SUBJECT: Forwards rev to 940314 response to NRC 931025 RAI re Topical
Rept WPPSS-FTS-131, "Applications Topical Rept for BWR
Design & Analysis."

Subject: **NUCLEAR PLANT NO. 2, OPERATING LICENSE NPF-21
REVISED RESPONSE TO REQUEST FOR ADDITIONAL INFORMATION
REGARDING TOPICAL REPORT WPPSS-FTS-131, "APPLICATIONS
TOPICAL REPORT FOR BWR DESIGN AND ANALYSIS" (TAC NOS.
M77048 AND M81723)**

**REVISED RESPONSE TO REQUEST FOR ADDITIONAL INFORMATION REGARDING
TOPICAL REPORT WPPSS-FTS-131**

**REVISED RESPONSE TO
REQUEST FOR ADDITIONAL INFORMATION
WASHINGTON PUBLIC POWER SUPPLY SYSTEM
TO REVISION 1 OF TOPICAL REPORT WPPSS-FTS-131**

Figure 27-11 FWCF Results, RPT Operable,
Tech. Spec. Scram Time

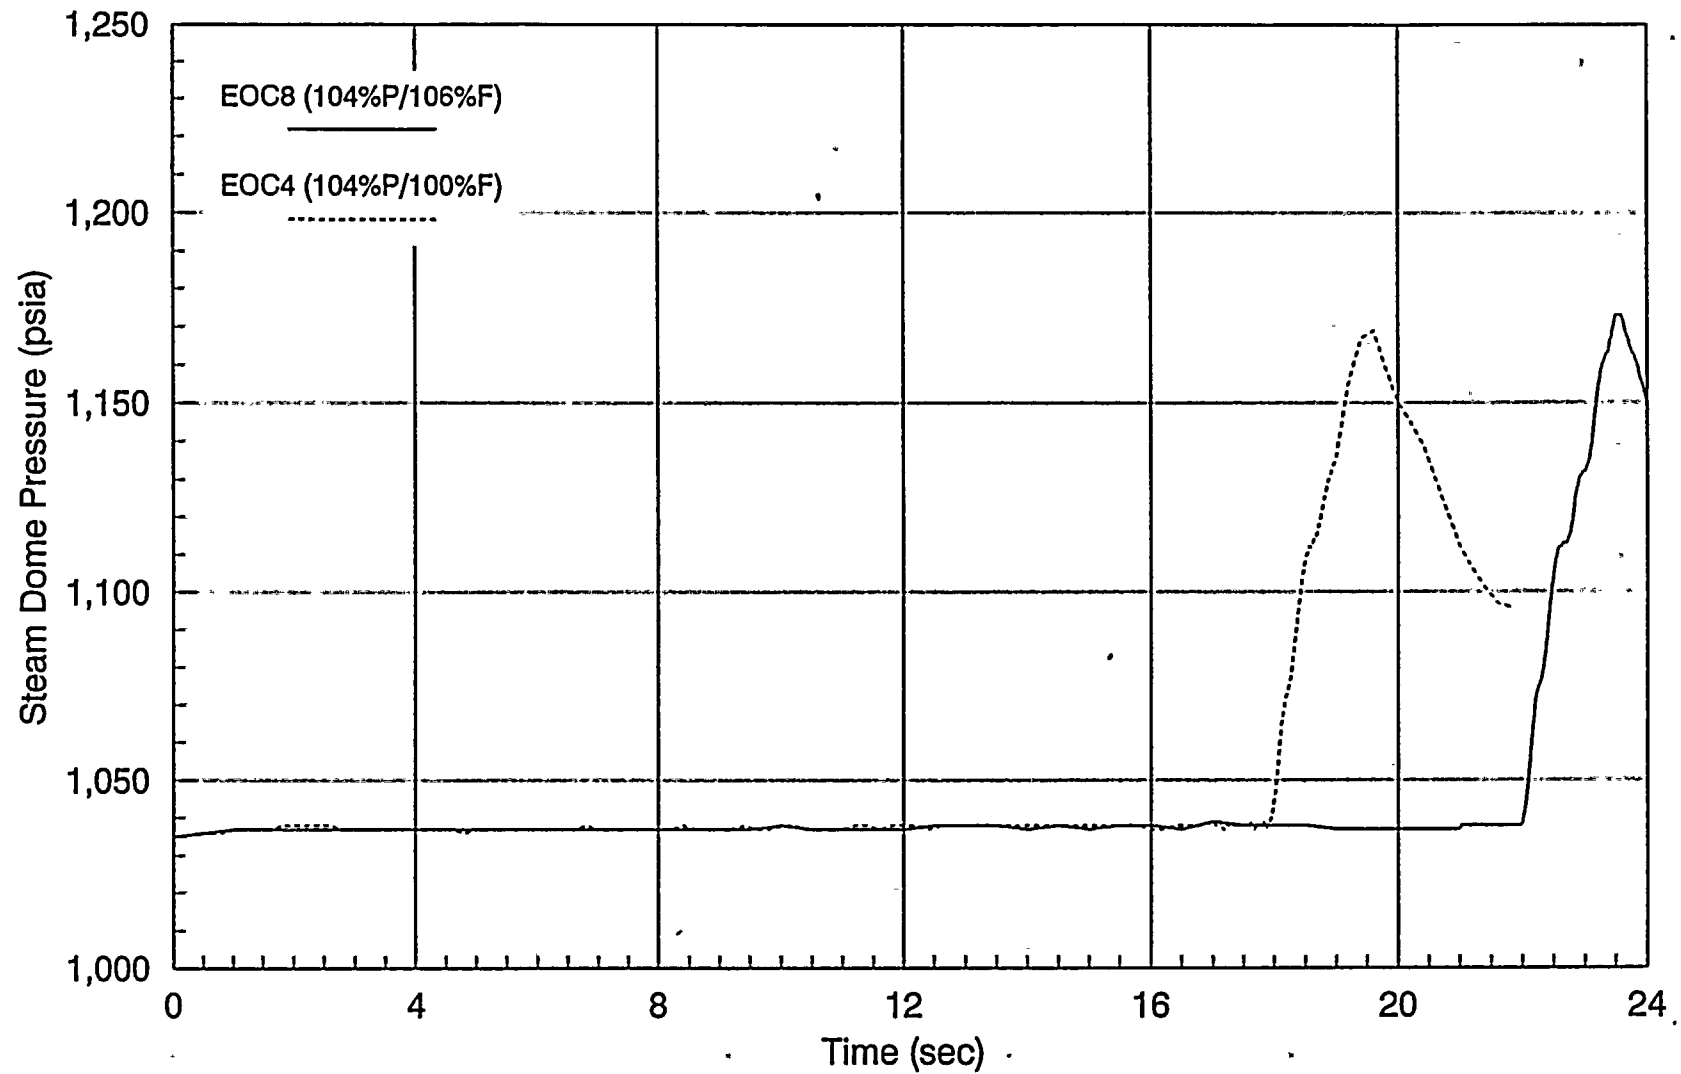
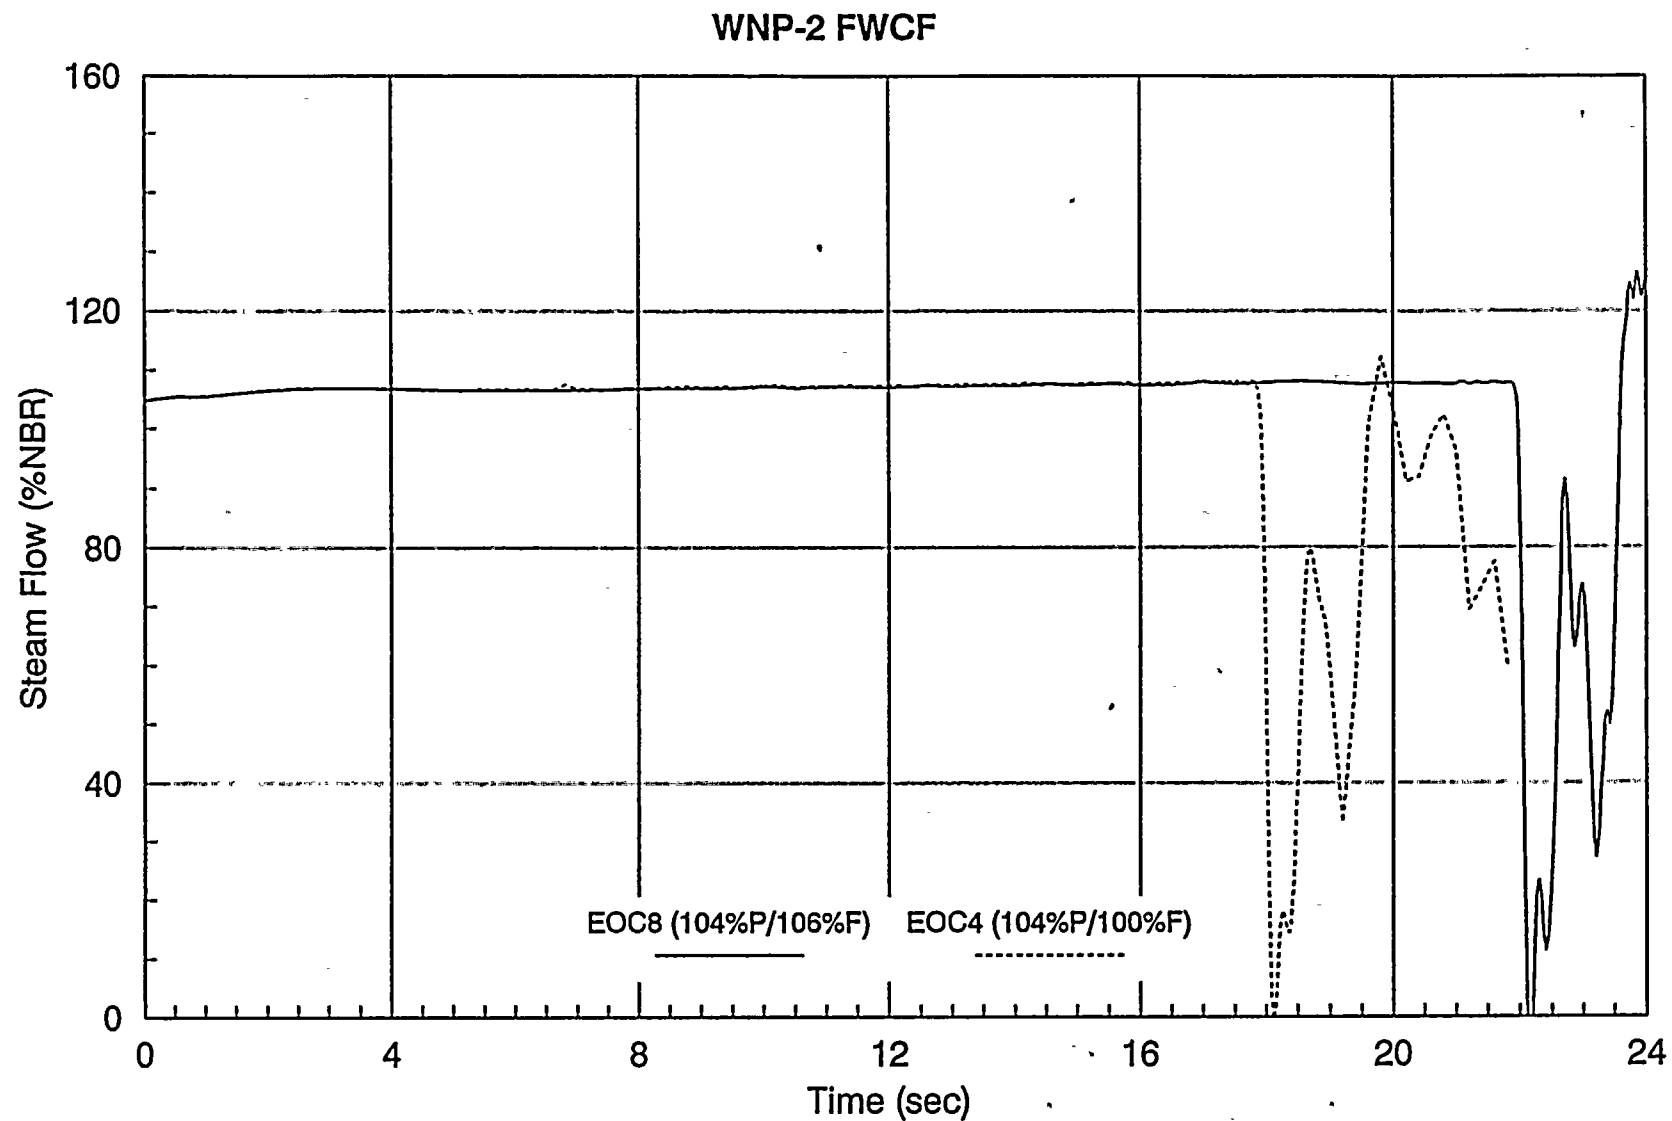
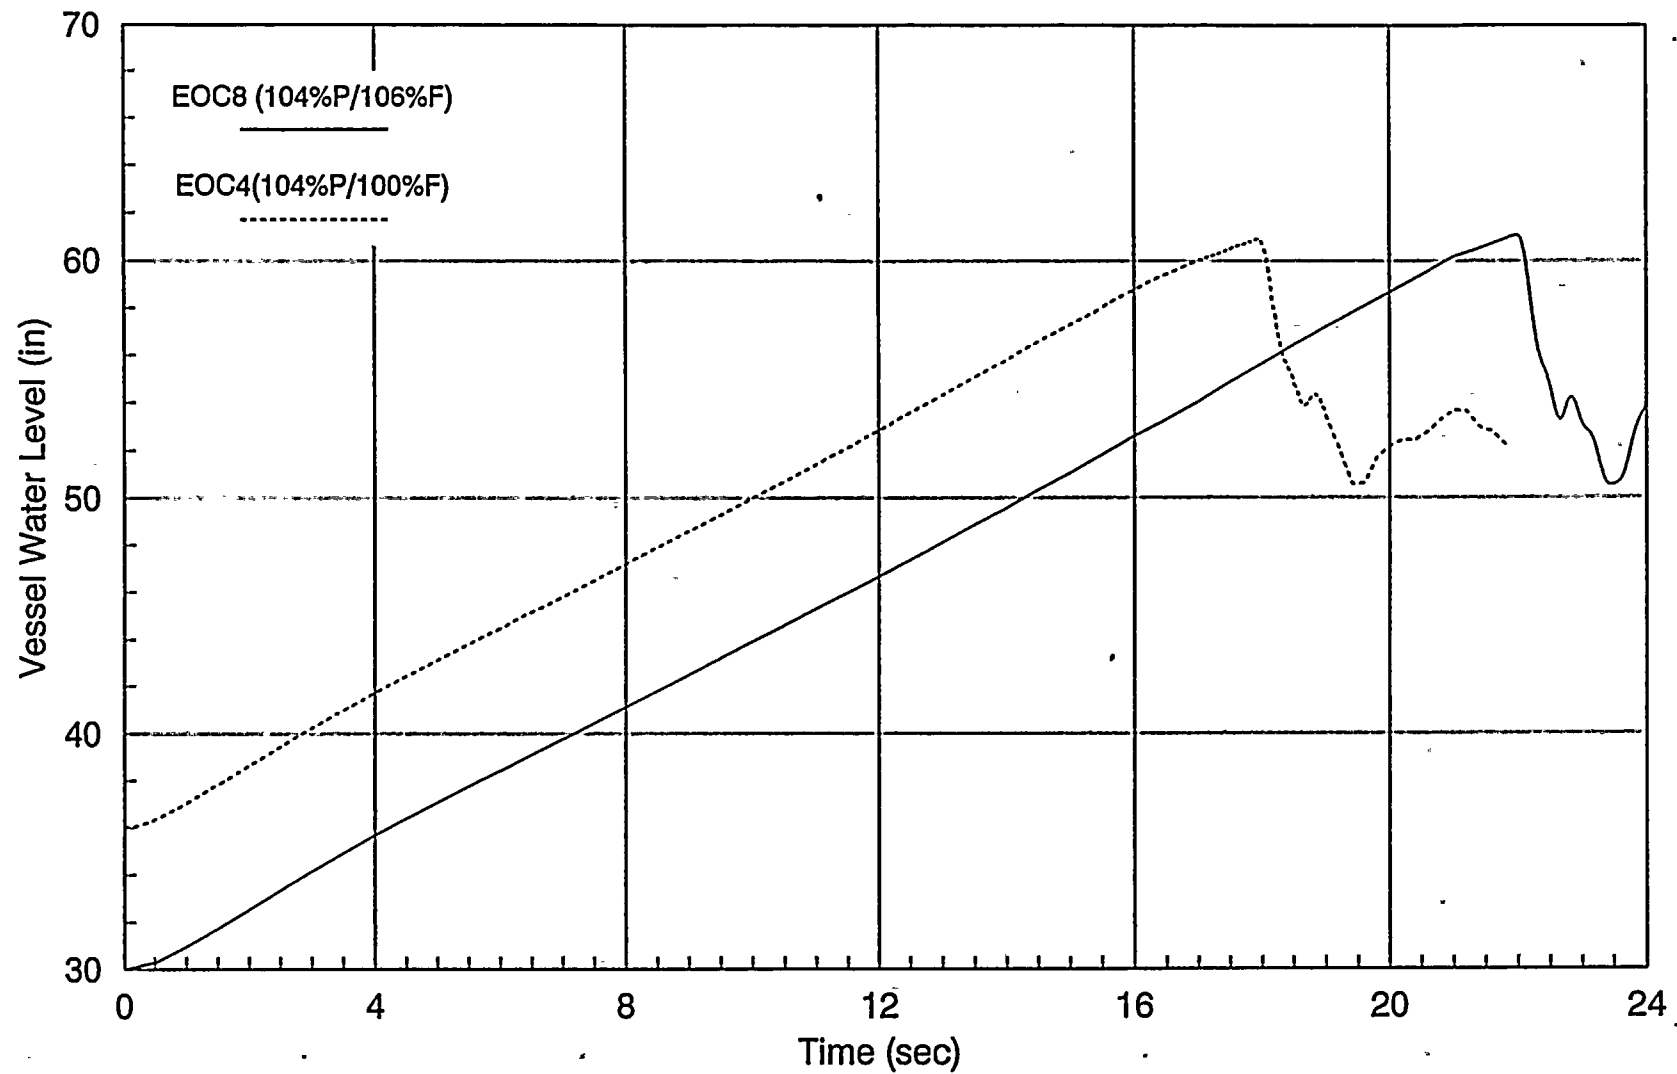
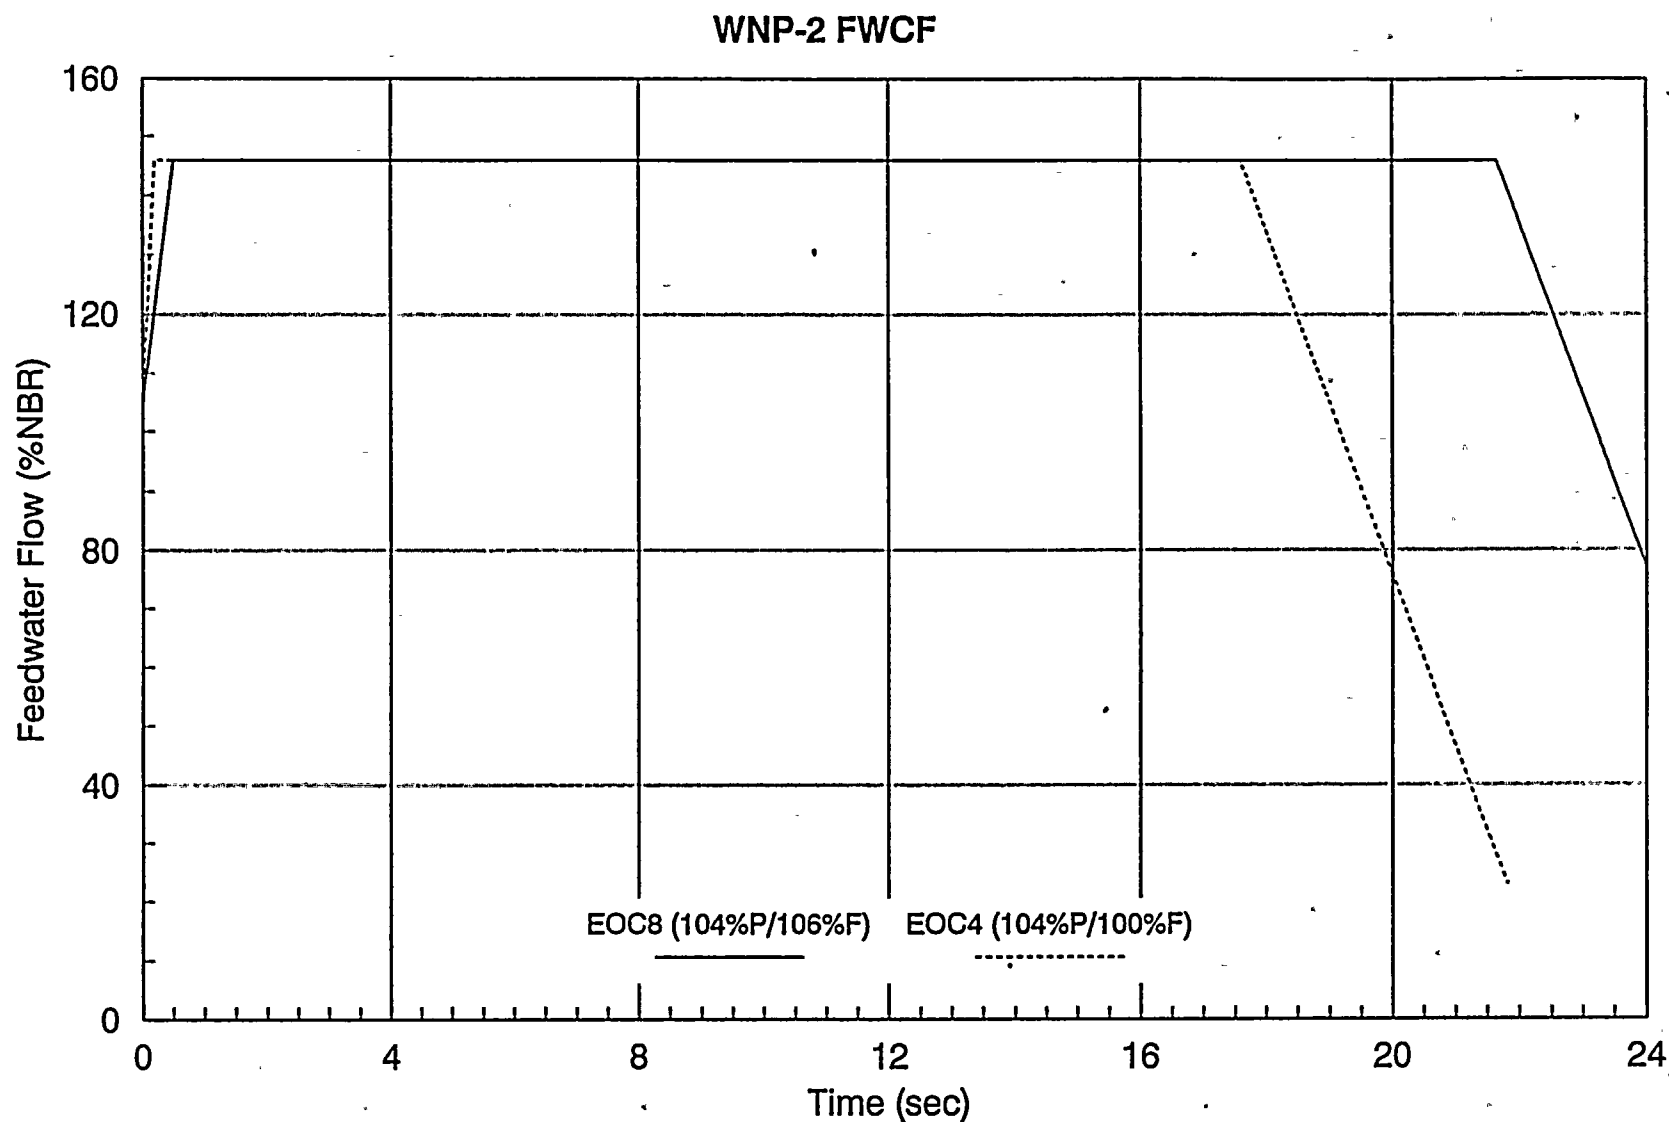
For the Feedwater Controller Failure event, there are dramatic differences between the results presented in Rev. 0 and Rev.1. Explain thoroughly these differences (shown on Tables 5.3.7-3 and 4 in Rev. 0 and Tables 5.3.7-4 and 5 in Rev. 1), and provide a complete set of plots comparing these two sets of analyses.

Improvements and corrections were made to the RETRAN-02 and VIPRE-01 models for WNP-2 after the Cycle 4 simulations were completed. The changes to the RETRAN-02 systems model included: vendor-based gap conductance methodology using the NRC approved RODEX2 code (see Applications Topical Report Revision 1); use of nominal recirculation pump inertia (see Response to Question 17); and mixed core modeling (see Response to Question 16). The initial water level at 104% power for the Cycle 8 analysis was a conservative value of low water level alarm L4 instead of the nominal level that was used in the Cycle 4 simulation. This causes a shift in turbine trip time as can be seen in Figures 27-8 through 27-14. The initial water level for the 47% power cases was set at L4 for both the Cycle 4 and Cycle 8 analyses. Also, the Cycle 4 analysis at 104% power used 100% core flow while the Cycle 8 analysis used 106% core flow.

The changes to the VIPRE-01 hot channel model are the use of vendor-based gap conductance and correction to the heated length calculation for the CPR correlation.
